BEFORE THE CENTRAL HAWKE'S BAY DISTRICT COUNCIL  
INDEPENDENT HEARINGS COMMISSIONER

**IN THE MATTER OF** A NOTIFIED RESOURCE CONSENT APPLICATION FOR  
SUBDIVISION TO CREATE 11 LOTS (8 RURAL LIFESTYLE  
LOTS, 2 BALANCE LOTS, AND A LOT TO BE  
AMALGAMATED AS A BOUNDARY ADJUSTMENT) AT  
MANGAKURI ROAD (RM230016)

**BRIEF OF EVIDENCE BY SIMON GABRIELLE**

*Figure 1 - Alternative dry pond position in Catchment C*

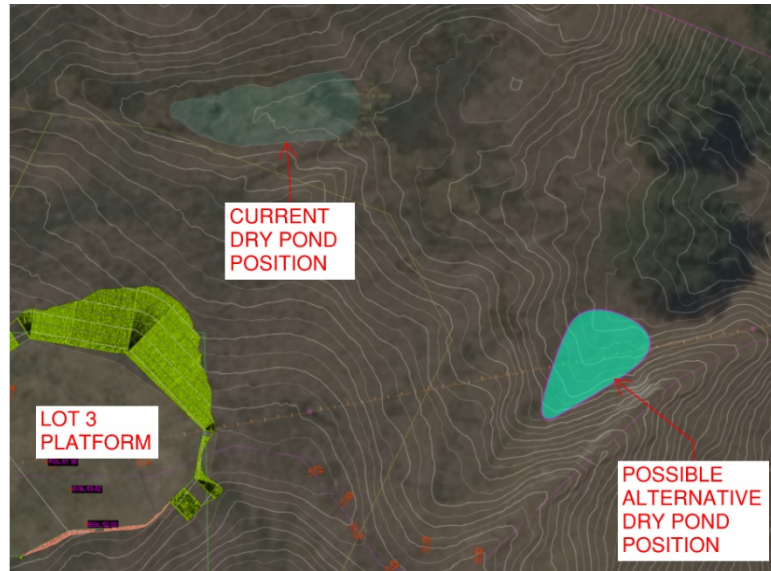
- 34 Regarding the proposed dry pond located in Catchment C as referenced by Ms Griffith, advice has since been sought from HBRC and based on a photograph of the site of the proposed dry pond, HBRC have advised that this area may be a natural inland wetland and that resource consent may be required under the NES-FW. The Applicant now plans to enlist the services of an ecologist to offer guidance regarding the potential wetland and explore potential improvement strategies according to the effects management hierarchy. This input will be utilized to prepare a resource consent application under regulation 45C of the NES-FW. If the ecological advice recommends against pursuing a resource consent application or indicates challenges in obtaining one in the currently proposed position north of Lot 3, alternative engineering solutions can be considered. Possible alternatives are outlined below to demonstrate the same level of stormwater detention can be achieved.

- 34.2 Another alternative is to relocate the proposed dry pond to the east of Lot 3 in the existing natural gully as shown in Figure 1. To achieve adequate stormwater detention, stormwater run-off from Lots 3 and 4 along with run-off generated from the accessway servicing Lots 3 and 4 could be conveyed to this pond position via pipes and or stormwater swales.

- 34.3 Outside of the alternatives discussed above, further options could be explored, including further alternative dry pond locations and or the use of above ground or in-ground tanks. Therefore, in my opinion there are viable alternative options to the originally proposed dry pond north of Lot 3, if an alternative is required.
